UNITED STATES
NUCLEAR REGULATORY COMMISSION
WASHINGTON, D. C. 20555

APPLICANT: Public Service Electric & Gas Company (PSE&G)
FACILITY: Hope Creek Generating Station
SUBJECT: SUMMARY OF STRUCTURAL AND GEOTECHNICAL ENGINEERING
BRANCH (SGEB) MEETING

On August 1, 1984, a meeting was held in the Bethesda, Maryland offices of the NRC to discuss the remaining SGEB-Structural audit open items identified in the Draft SER. A list of meeting attendees is included as Enclosure 1 to this meeting summary.

FIGURE 1 -

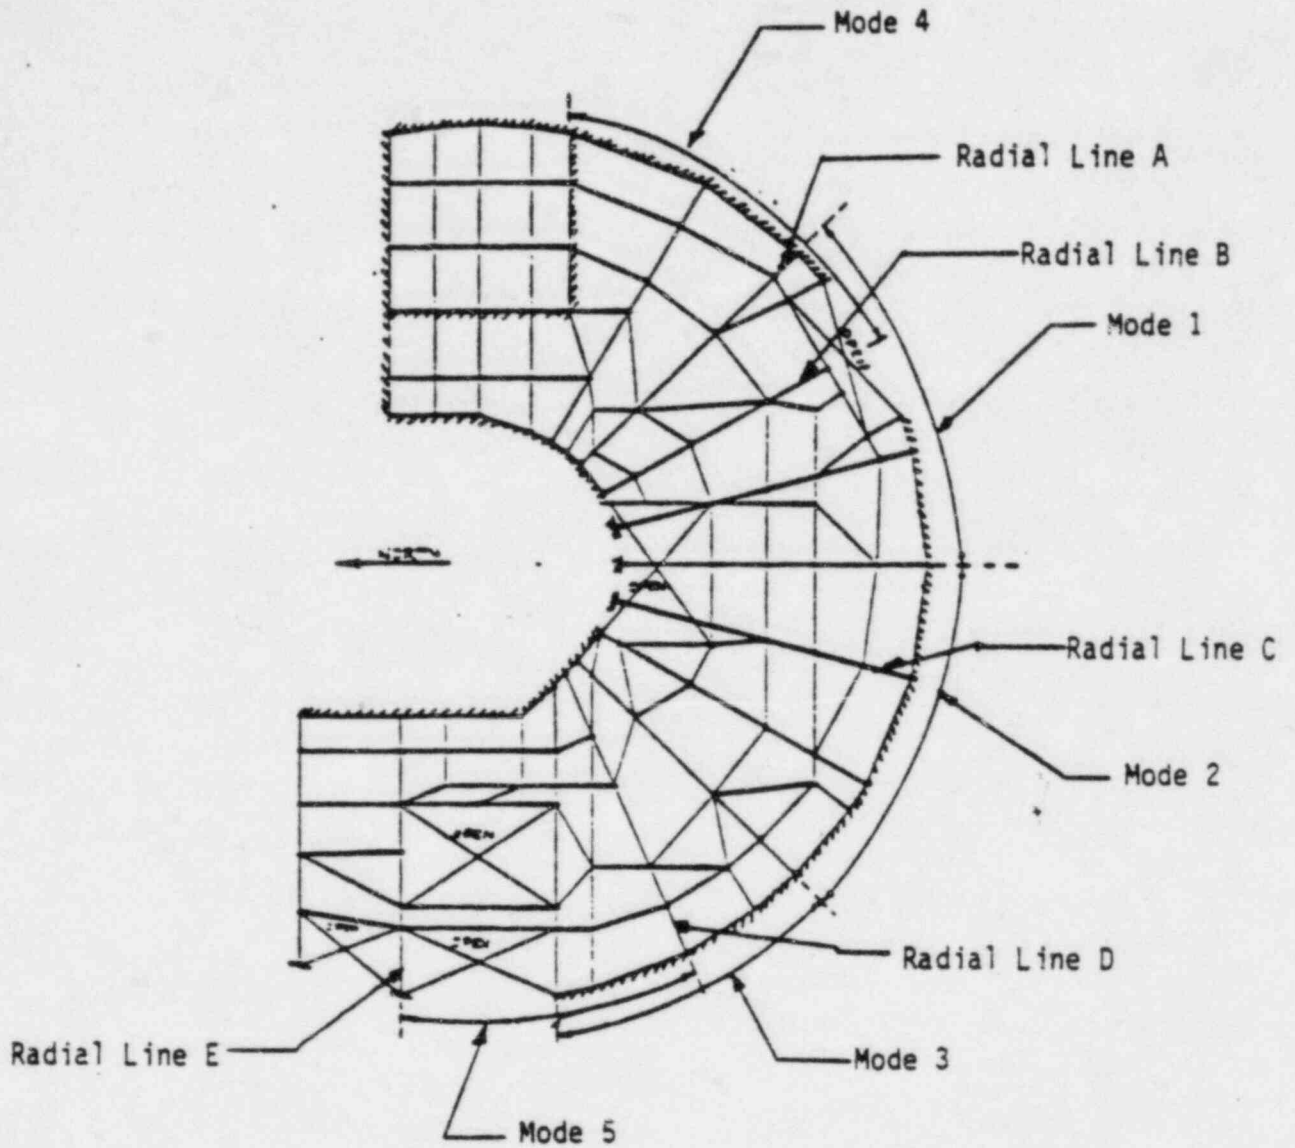
Provide the frequencies and mode shapes used to develop vertical floor flexibility spectra for elevation 145 feet of the Reactor Building.

For the Reactor Building floor slab at elevation 145.0 feet, five modes were used. Based on the mode shapes of these modes, these modes were determined to represent five different regions of the floor slab, as shown in Figure 1. These five modes were represented by five single-degree-of-freedom beam elements in the vertical floor flexibility model shown in Figure 2.

RESPONSE: Figure 1 shows the finite element model of the Reactor Building floor at elevation 145 feet. Regions where the response of each mode is dominant is also shown in Figure 1.

Figure A-13-1
Division of Responsibility

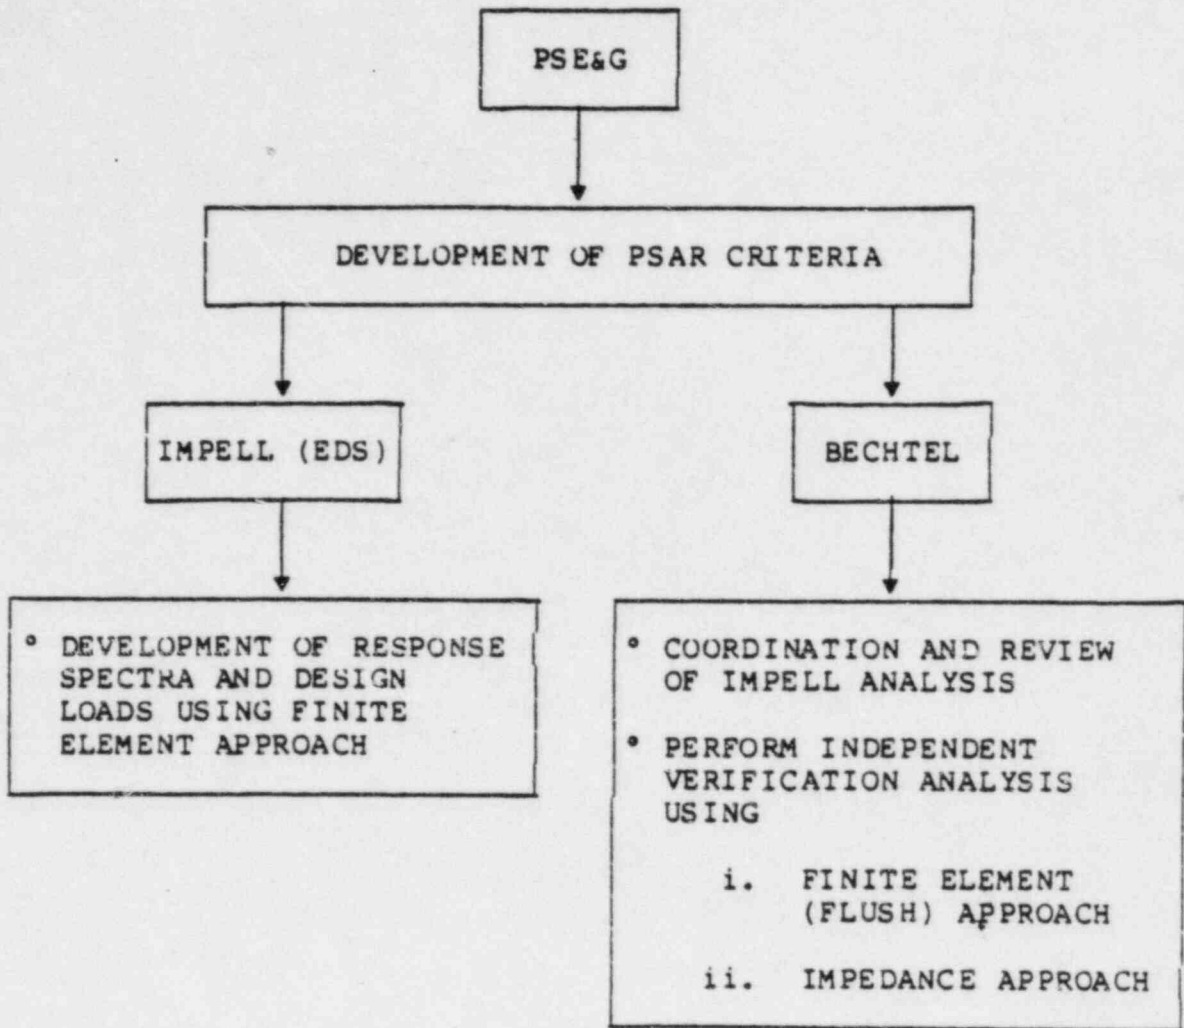
Question: Provide comparison of Bechtel Independent Verification Results with the Design Basis Results.

As described in Amendment 1 of the FSAR (Section 3.7.2.4), three independent seismic soil-structure interaction analyses are performed for the major plant structures. The design basis analyses are performed using the finite element method by EDS Nuclear, Inc. (presently known as Impell Corporation). Independent finite element soil-structure interaction analyses are subsequently performed by Bechtel to verify the design basis analyses. In addition, in accordance with the requirements of the Standard Review Plan, Section 3.7.2 (NUREG 0800), impedance approach (the half-space) soil-structure interaction analyses are performed by Bechtel. The analytical method utilized for the impedance approach seismic soil-structure interaction analyses of power block structures and service water intake structure is given in FSAR Section 3.7.2.1. Figure A-13-1 summarizes the division of responsibilities for the seismic analyses.
